# Product Change Notification

## PANEL CONTROLS

## Model PC Termination Ink Upgrade

*Element Collector Ring*

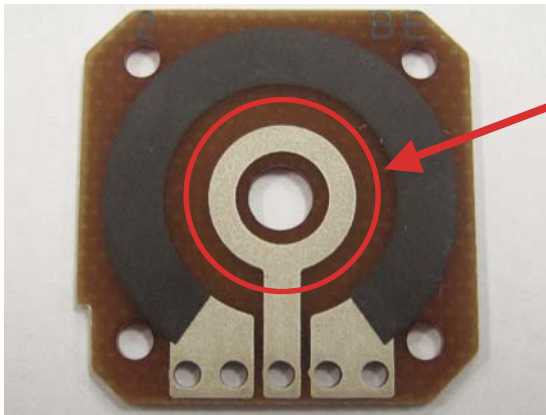
The current termination ink used in printing the collector ring is CPC-30. This ink will be changed to Minico 4100, which has improved wear characteristics. Please refer to the photo showing the area where the collector ring is printed on the element.

This termination ink upgrade does not affect fit, form or function of the product. Production transition to the new termination ink started the week of September 18, 2007, with date code 0738M. Qualification test data is available upon request. There will be no changes to MOQ/Mults or price on this product upgrade.
